Does KTS have a maximum upset budget for the pump track? \$100k or \$350k? Aware of the recent grant, but unsure if some of this budget is being split to other bike park amenities, site preparation etc or it all has to be spent on the pump track?

Please provide maximum site extents/boundaries for proposed development.

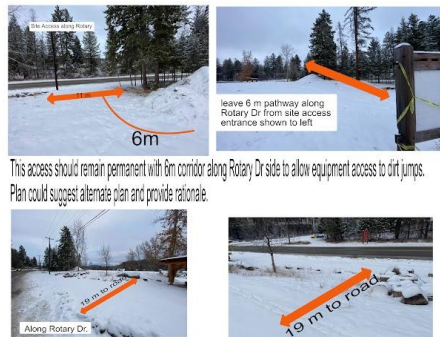
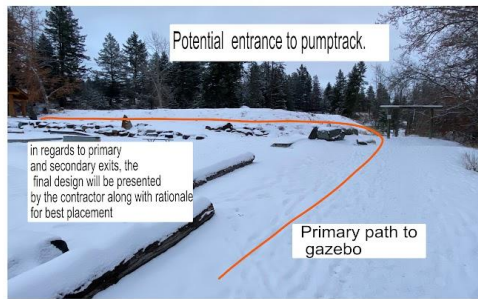
Is water available for construction on site? Water utilities are shown adjacent to the West corner of the skate park.

Yes water is available from the building at the NW corner of the existing skatepark.

Site Access Considerations

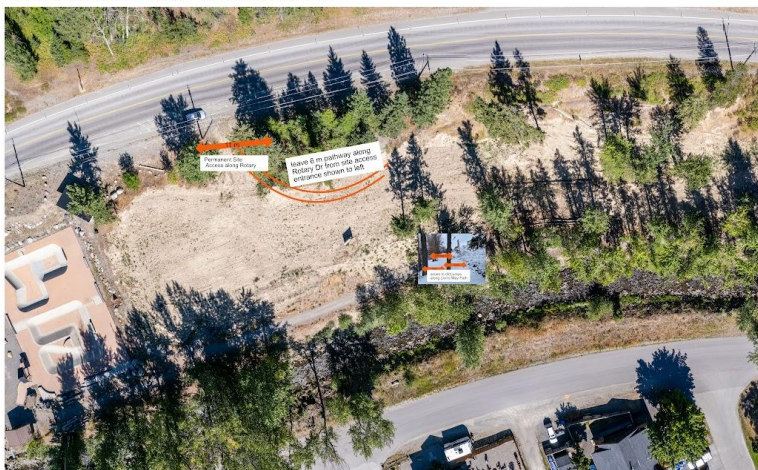
Please confirm principle site access for construction to be off Rotary Drive.

It appears that if the pump track is completed prior to dirt jumps, the only site access for Dirt Jump material import will be via Mark Creek Trail. Should the pump track contractor ensure that pad & ramp access is retained for DJ access upon completion?

Yes, primary site access will be from Rotary Drive. Some access is available along Mark Creek Trail. Future access should be at least 6m from Rotary Drive to access the dirt jump area without disturbing the pumptrack and 2m along the Mark Creek Trail.

Reasonable site access will be available from the Matthew Creek Trail from both ends. If the Pump Track is built first, considerations for larger machinery will need to be made depending on the successful bidders of both projects' machine and design plan. Ideally, the dirt jump project will be completed before. We are hoping to have the dirt jump project completed in the spring to avoid issues with space and access. The final design should leave some future access which will likely be off Rotary drive and smaller access from the Mark Creek Trail. See included pictures for Site Access Considerations.
